The purpose of this report is to provide information on the potential impact on the security of supply, in south east Queensland (SEQ) if a significant volume of water was released from the water supply capacity of Wivenhoe Dam as a potential flood mitigation measure.

As you are aware, the Commission has now finalised a draft report as input information material for Seqwater, as requested by the Minister (attached), titled *Impacts on SEQ Water Strategy of Various Operating Scenarios for Wivenhoe Dam, 14 February 2011, Version 6*. The purpose of this report is to provide information on the potential impact on the security of supply in SEQ if a significant volume of water is released from the water supply capacity of Wivenhoe Dam as a potential flood mitigation measure. The information in this report has been shared with Seqwater officers during the course of its preparation, and a full version provided to you on 12 February 2011.

Figure 3: Simulated Grid 12 storage levels for 3 inflow scenarios

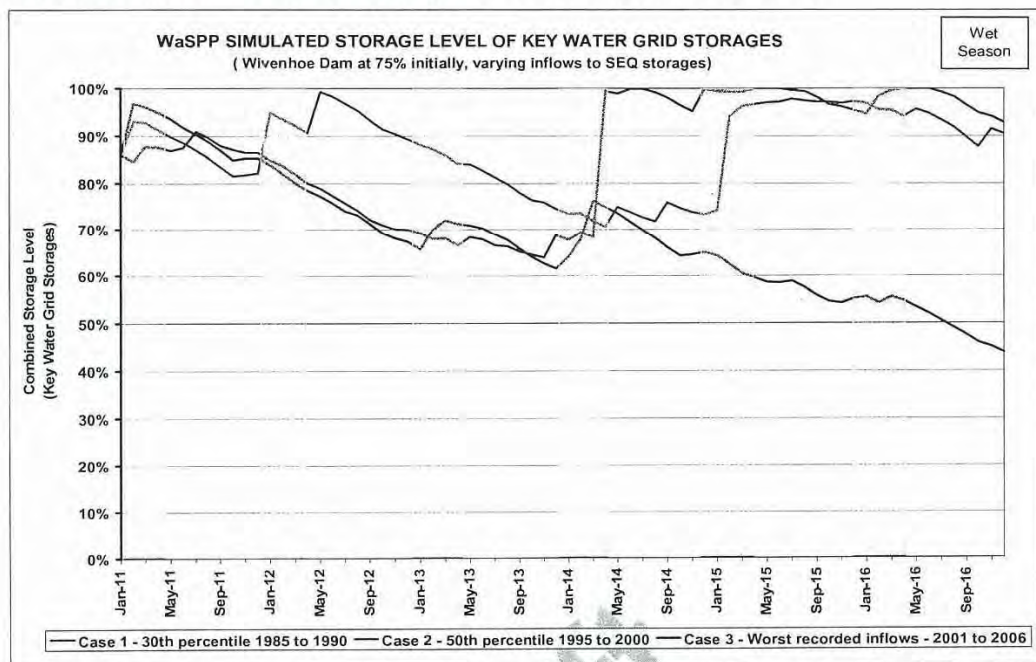
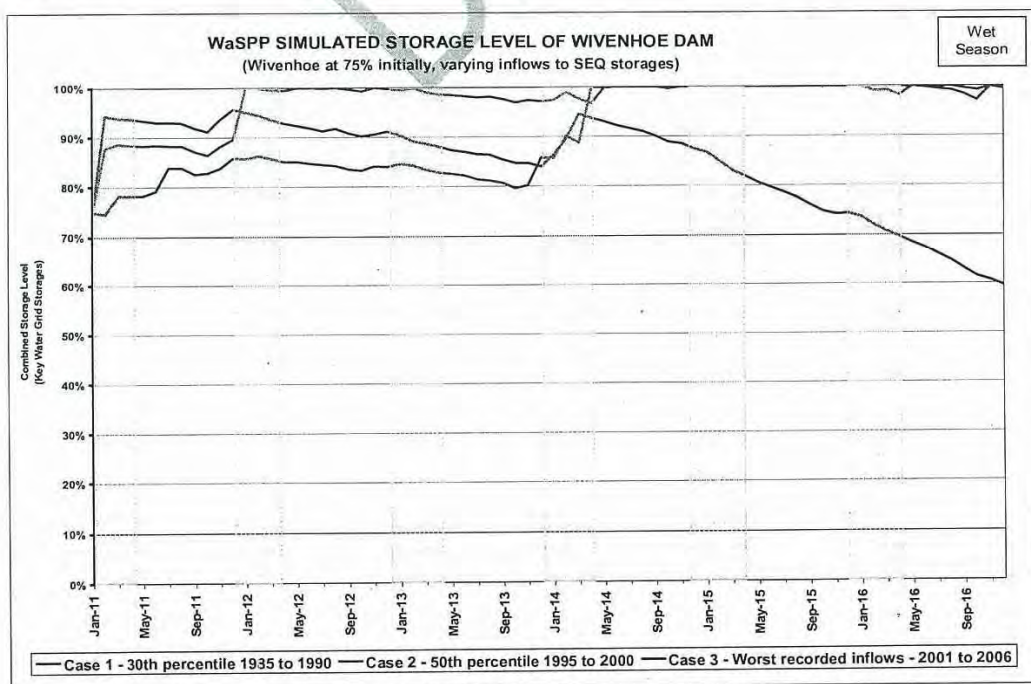
2. To assist in how the assessment and analysis in the report makes the case consistent with its recommendations – it is recommended that you consider re-presenting the Figures 3 and 4 to show the impacts of 100%, 75% and 50% on Grid 12 combined storage and Wivenhoe storage levels, together with realigning the time period used in the modelling to commence February 2011. This may provide a more readily understandable illustration of the three scenarios.
